PROJECT: ALABAMA COMMUNITY COLLEGE SYSTEM WORKFORCE SKILLS TRAINING CENTER
GMC PROJECT NO. ABHM210048

ADDENDUM NUMBER 02

PROJECT: **ALABAMA COMMUNITY COLLEGE SYSTEM WORKFORCE SKILLS TRAINING CENTER**
GMC PROJECT NO. ABHM210048

1 SECTION
S3.01A 3/4" = 1'-0"

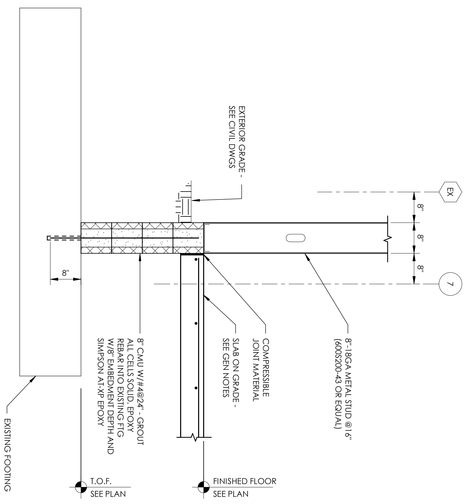
NO.	Asker	Question	ADD #	Response
26	F	Detail 1/S3.01 shows the following in the descriptions. 8" - 18GA metal stud framing 16" o.c. (600S200 - 43 or equal) Please confirm that it should be: (or not) 8" - 18GA metal stud framing 16" o.c. (800S200 - 43 or equal)	2	800S200-43 or equal is correct.
27	F	Addendum 1 references the wet well depth changing, but the elevations are the same. Please advise.	2	Elevations are correct in AD 01.
28	F	Per architectural RCP ceiling plan in the finish legend is ACB-1 Turf Straight Blades, but none are called out within the drawings. Are these to be involved in a specific area and if so, will you be providing an updated drawing to show where they are to be located?	2	See drawings. ACB-1 baffles are called out on RCP sheets A2.01 and A2.02.
29	F	The specs call for type 4 membrane which is hot applied, but typically type 4 is not used where there are turn-up sections. Please confirm type 4 is wanted at the turn up areas, and if not then what type of membrane is wanted there? Please provide a list of manufacturers.	3	Roof parapet details to be revised in AD 03 on 09.05.2023.
